Source: Philips
Title: Editorial correction to timing relations
Document for: Discussion

25.211 CR 050

Subject: Editorial correction to timing relations

Clauses affected: 7.7 Timing relations for initialisation of channels

Figure 32: Timing for initialisation of DCH.

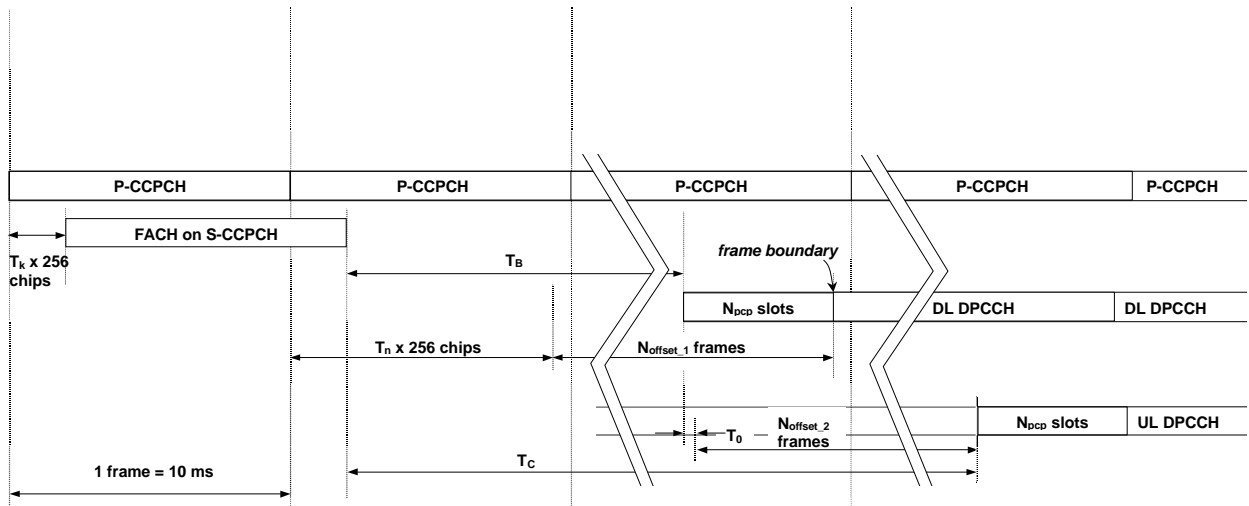
Figure 32 shows the timing relationships between the physical channels involved in the initialisation of a DCH.

In order that $T_B \geq T_{B-\min}$, any activation time specified for the downlink (as described in TS25.331) should be such that N_{offset_1} as shown in Figure 32 is ~~shall be~~ an integer number of frames such that:

The starting time of the uplink DPCCH is shown in Figure 32 as occurring ~~shall commence~~ at a time T_C after the end of the relevant FACH frame. The starting time of the uplink DPCCH is determined by higher layers, according to the activation time of the uplink, if one is specified.
